**REGULAR MEETING OF THE CITY COUNCIL  
PLANTATION, FLORIDA**

**January 13, 2016**

- 18.** DEFERRED PUBLIC HEARING AND FIRST READING OF AN ORDINANCE PERTAINING TO THE SUBJECT OF COMPREHENSIVE PLANNING; ASSIGNING 150 RESIDENTIAL UNITS IN THE LOCAL ACTIVITY CENTER (LAC), TO THE FOLLOWING DESCRIBED PROPERTY IN FLEX ZONE 73 SO AS TO PERMIT THE CONVERSION FROM COMMERCIAL TO RESIDENTIAL USE: PROPERTY LYING IN SECTION 1, TOWNSHIP 50 SOUTH, RANGE 41 EAST, AND DESCRIBED AS A PORTION OF PARCEL "A" PLANTATION BUSINESS CENTER, ACCORDING TO THE PLAT THEREOF AS RECORDED IN PLAT BOOK 125, PAGE 40 OF THE PUBLIC RECORDS OF BROWARD COUNTY, FLORIDA MORE PARTICULARLY DESCRIBED HEREIN AS EXHIBIT "A", GENERALLY LOCATED AT THE NORTHEAST INTERSECTION OF NW 46 AVENUE AND NW 8 STREET; PROVIDING FINDINGS; PROVIDING A SAVINGS CLAUSE; AND PROVIDING AN EFFECTIVE DATE THEREFOR. (STRATA).

**REQUEST:** Assignment of LAC units, site plan, elevation, and landscape plan approval for a 150-unit townhouse development.

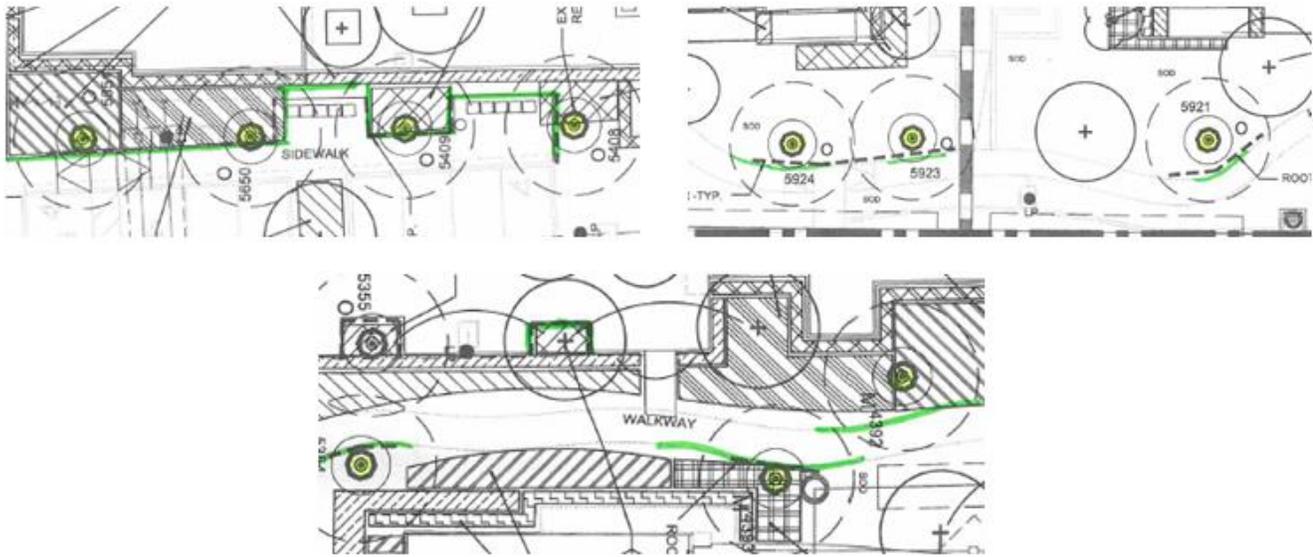
1. **Staff does not support the removal of "Good" quality, Calophyllum trees, and/or Sabal palms throughout the site. As per City codes every reasonable effort must be made by the proponent to incorporate existing trees in the development project.**

2. As per City codes a minimum of 1 tree is required every 30 lineal foot, or fraction thereof, of façade width (3 palms = 1 tree). **Existing trees planted within 1'-5' of a proposed sidewalk will not count towards code required trees throughout the landscape pedestrian zones. (Please see figure under item #3.)**

**Examples of existing trees with established root systems within 1'- 4' of proposed sidewalks throughout the site.**

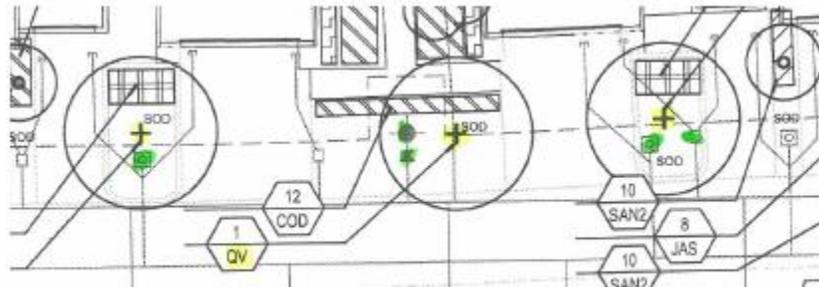
***Existing trees planted within 1'-5' of a proposed sidewalk will not count towards code required trees throughout the landscape pedestrian zones. (Please see figure under item #3, Planting Plan comments.)***

3. While staff appreciates the attempt to save existing trees throughout the site – **staff does not support** the proposed sidewalks are planted within 1'- 4' of existing trees (i.e. tree #5408, 5650, 5409, 5664, 3958, 4393, 5354, etc.). Sidewalks, paved areas, etc. must be placed a minimum of 8' from existing trees. Proposed paved areas must not compromise the health of existing trees.
